MONITORING YEAR 3 ANNUAL REPORT

LONE HICKORY MITIGATION SITE

RE: Lone Hickory Mitigation Site – Monitoring Year 3 Report Draft
Yadkin River Basin – CU# 03040101 – Yadkin County
DMS Project ID No. 97135
Contract # 6897

Wildlands Engineering, Inc. (Wildlands) has reviewed the Division of Mitigation Services' (DMS) comments from the Draft Monitoring Year (MY) 3 report for the Lone Hickory Mitigation Site. DMS' comments are noted below in **bold**. Wildlands' responses to those comments are noted in *italics*.

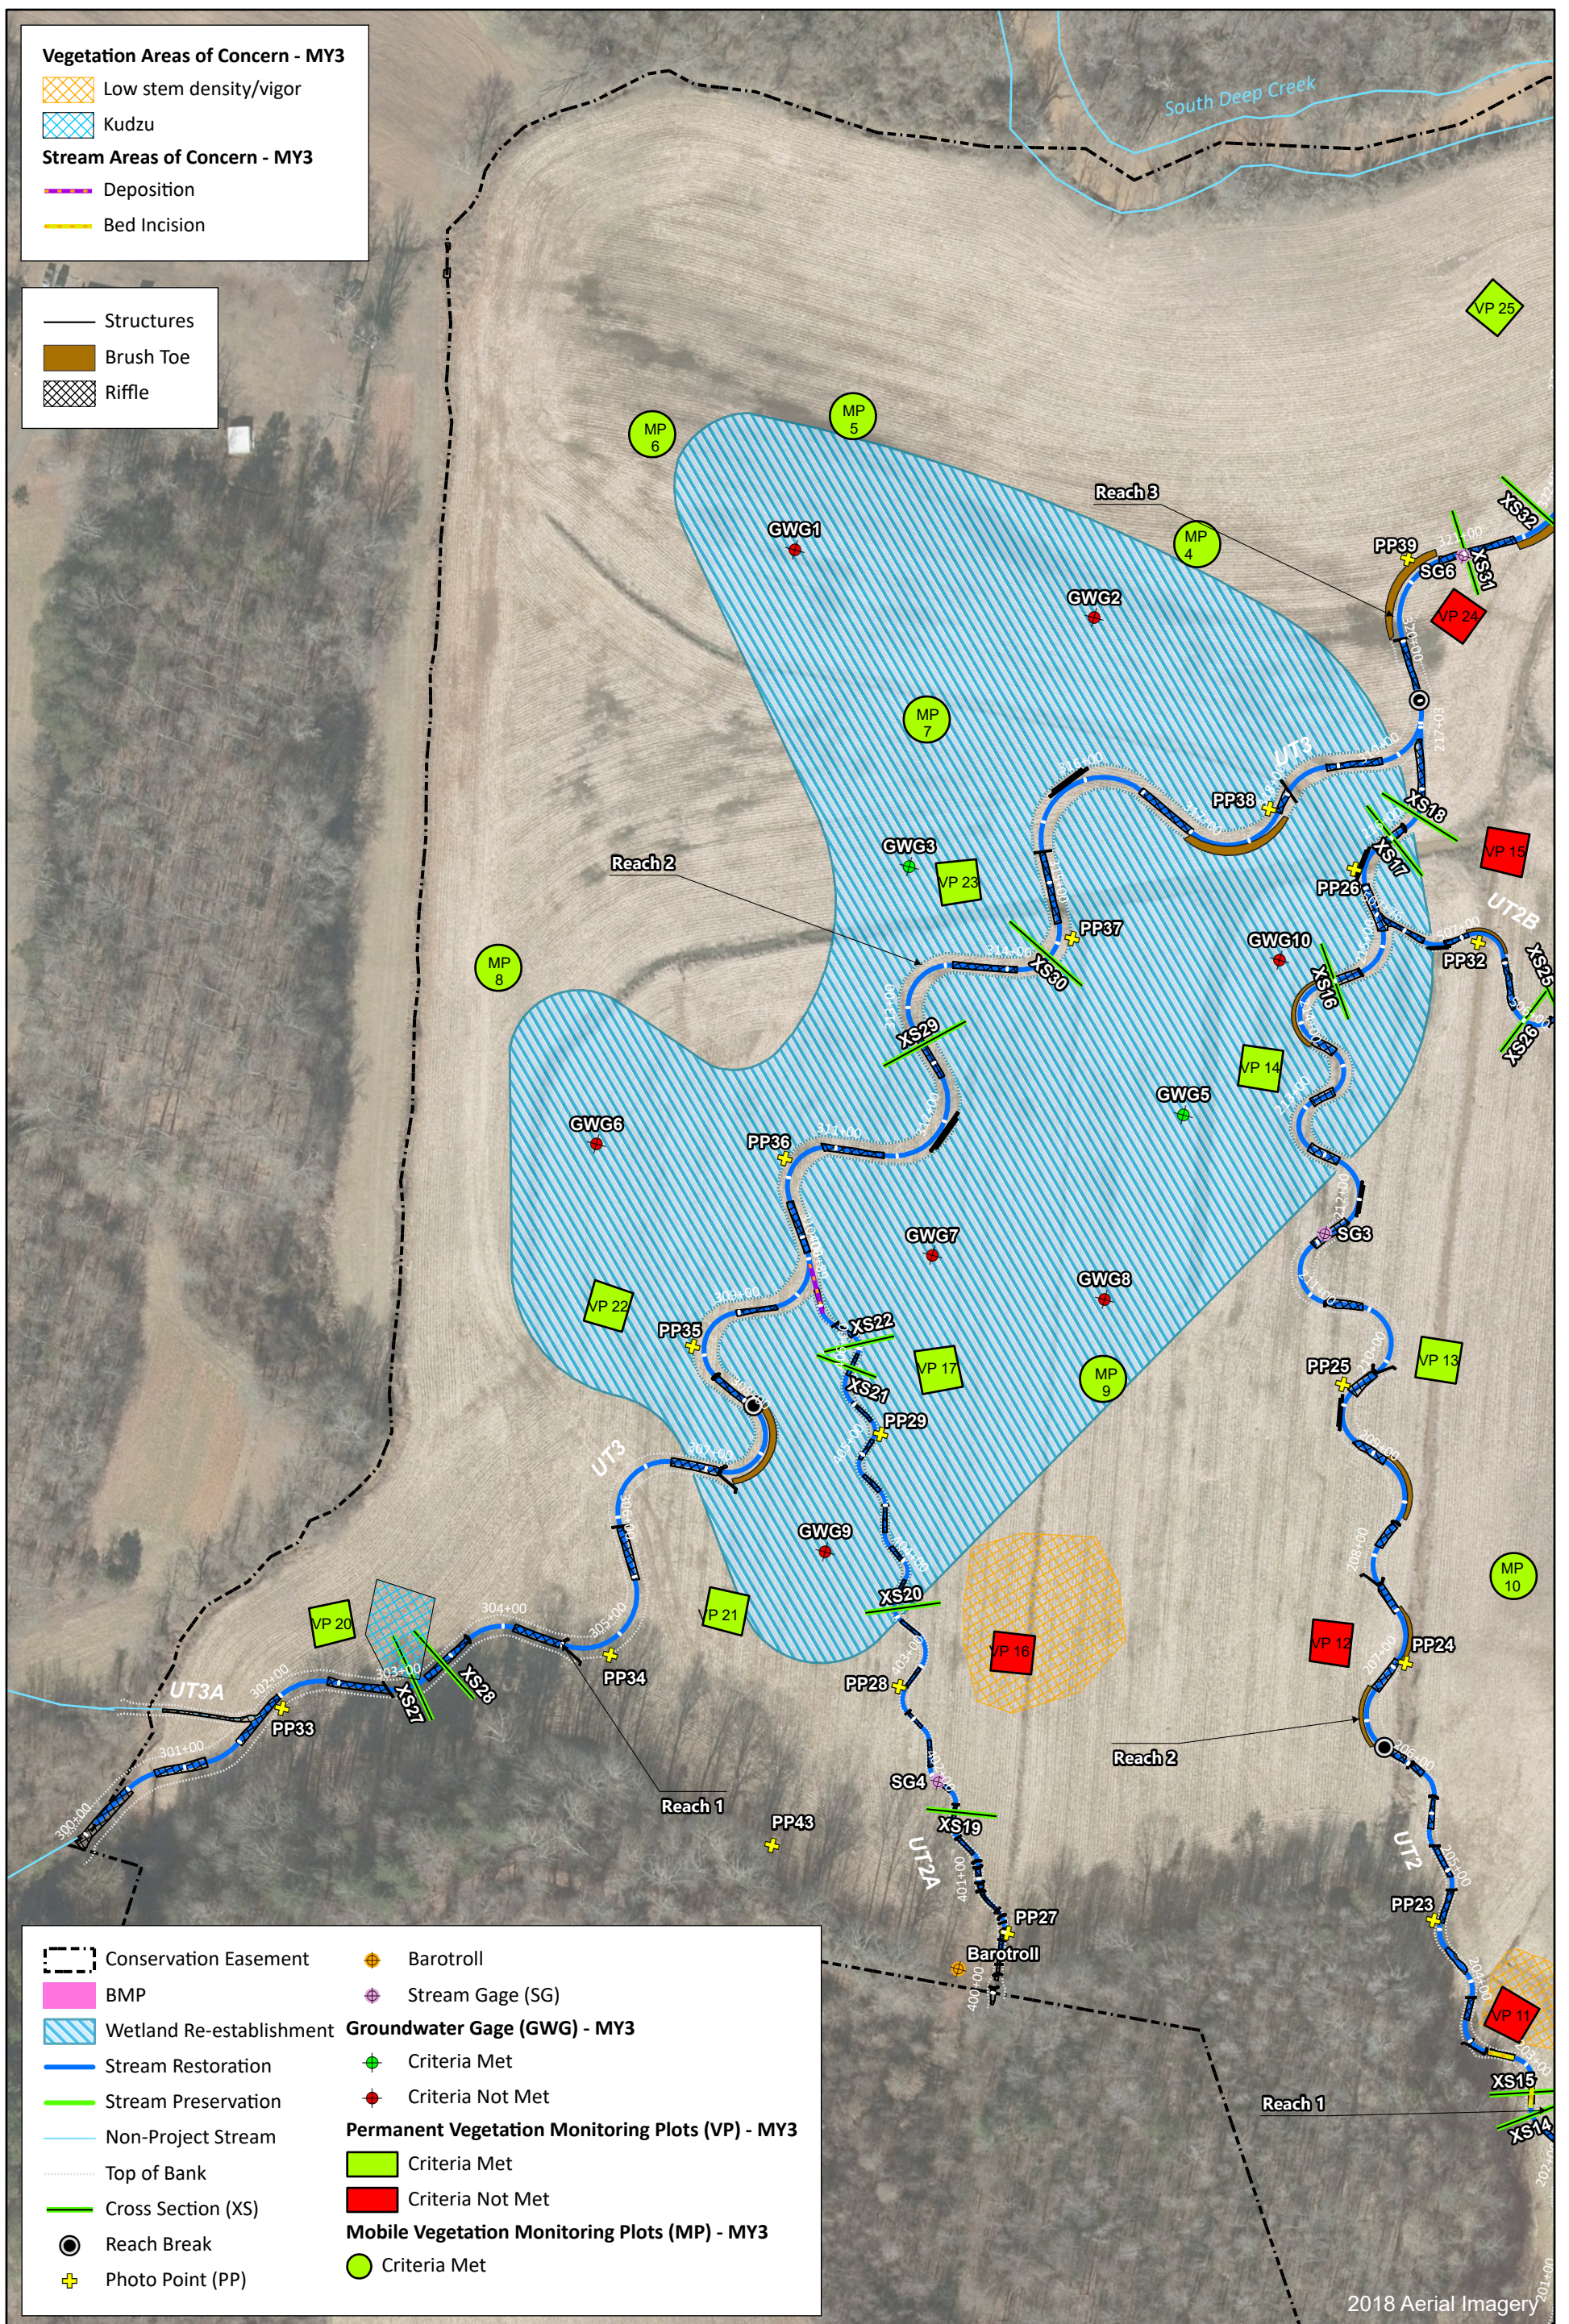
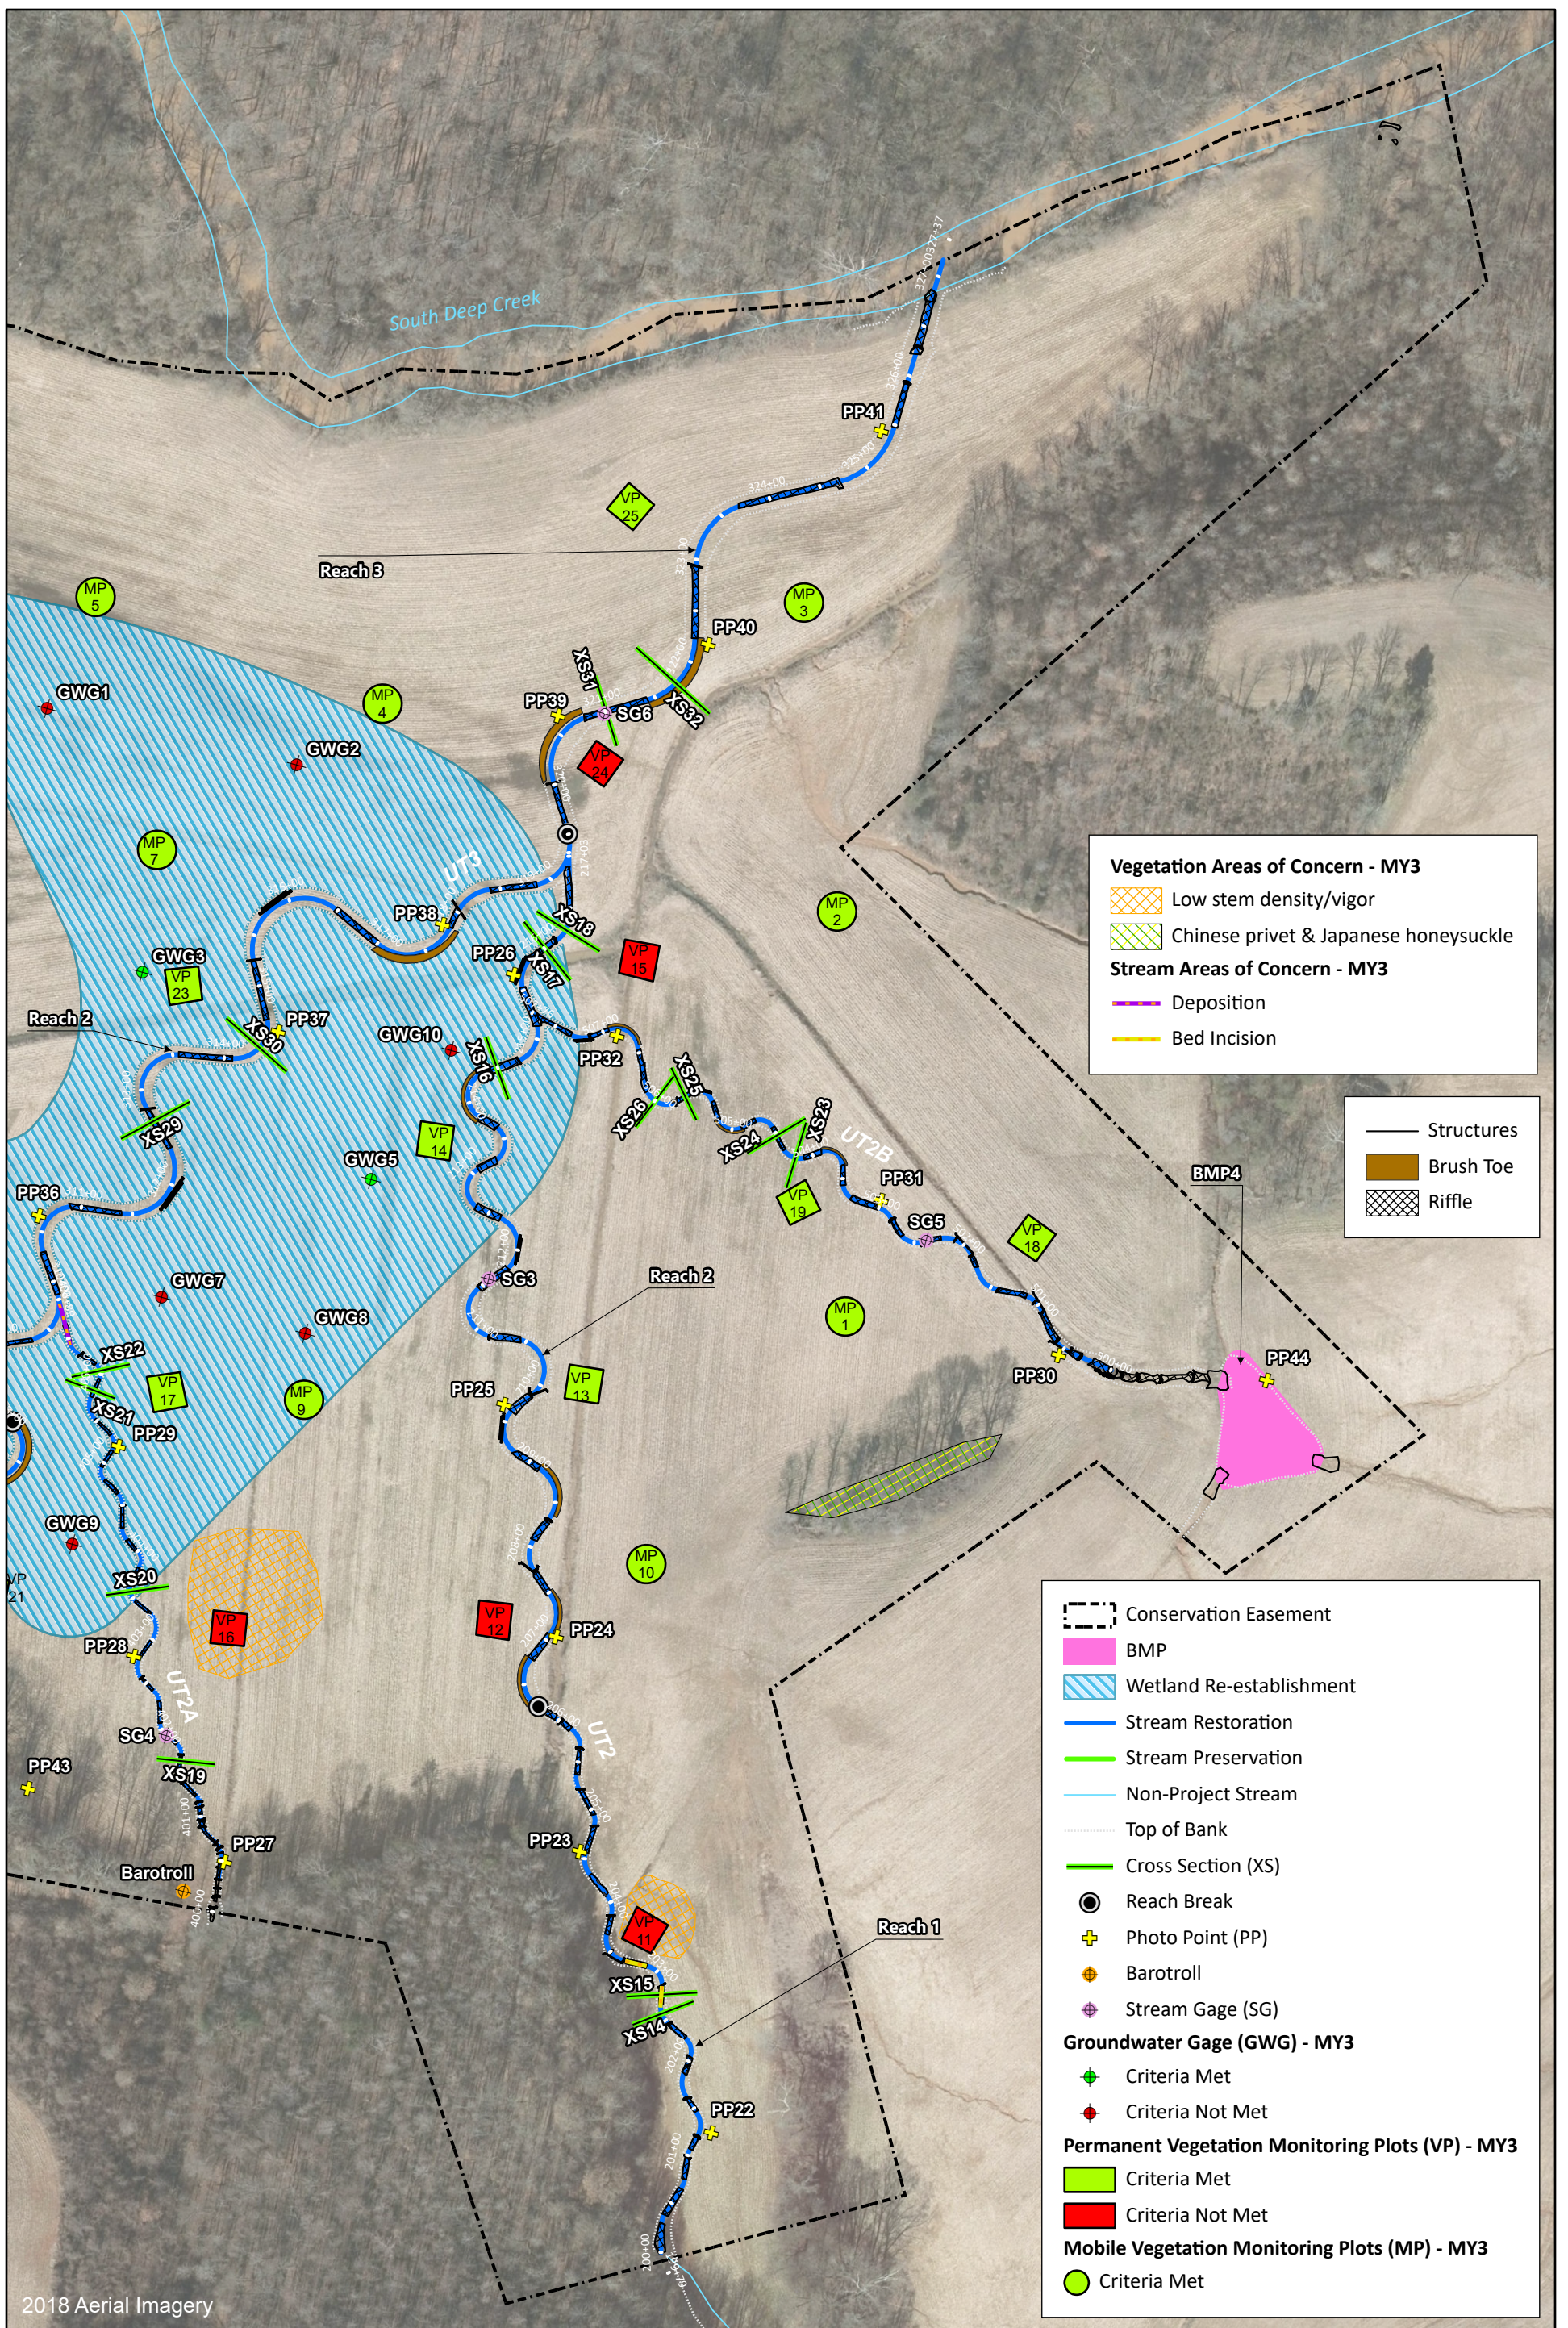
DMS' comment: Section 1.2 Monitoring Year 3 Data Assessment/ 1.2.5 Areas of Concern and Management Activities: The CCPV maps and Table 6 report two (2) structure issues on UT1 Reach 1. Please briefly discuss these structure issues in the report text.

Wildlands' response: Text discussing the structure issues on UT1 Reach 1 has been added to Section 1.2.5.
